Remi Holdings Ltd.

Plot No. 244-245 & 250-251, Road-01, Adamjee Nagar, EPZ, P.S.
Shiddhirganj, Narayanganj
(23.681092N, 90.517714E)

22 June 2016

Observations

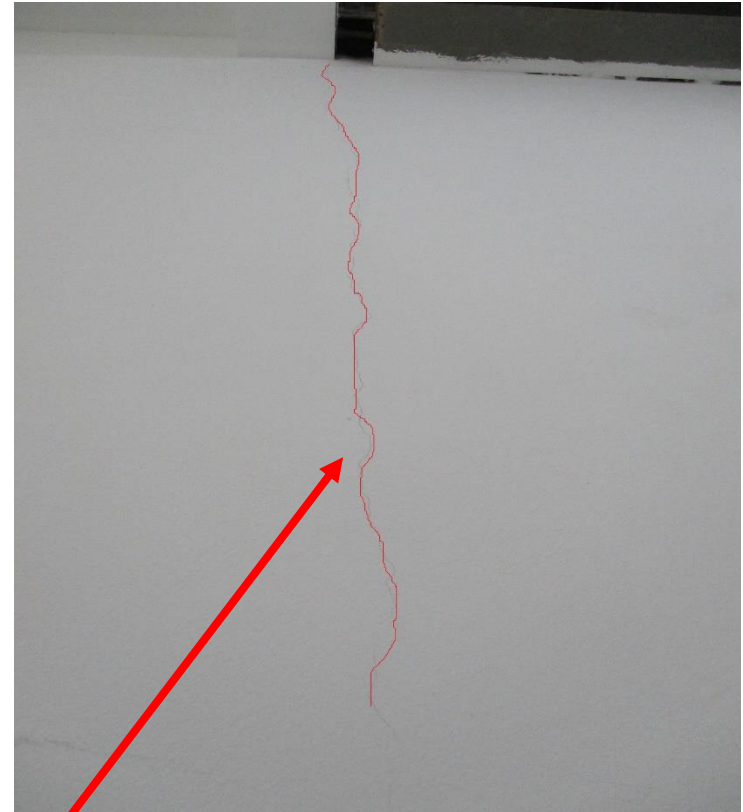
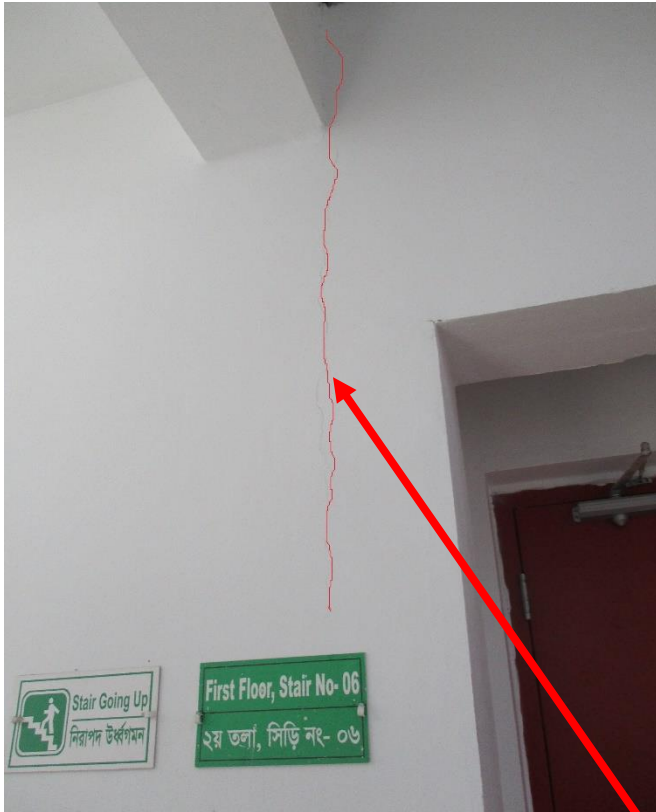
Missing Connection bolts in the Roof steel frame of the B1 (Main Production building)

Missing Connection bolts
in the Roof steel frame
connection observed of
the B1 (Main Production
building)

Missing Connection bolts in the Roof steel frame of the B1
(Production building)

Item No.	Observation	Recommended Action Plan	Recommended Timeline
1	Building 1. Missing Connection bolts in the Roof steel frame of the Main Production building	Building Engineer to identify all the omissions and supervise remedial works to the missing bolts in the connections.	6-months
2	Building 1: Cracks in interior brick walls of main production building.	Building engineer investigate extent of cracks.	6-months
3	Building 1. Corrosion in sheeting and structural members of main production building	Building Engineer to issue a schedule of remedial works for bracing reinstatement and corrosion protection.	6-weeks
4	Building 1. Corrosion in sheeting and structural members of main production building	Remedial works to be carried out.	6-months
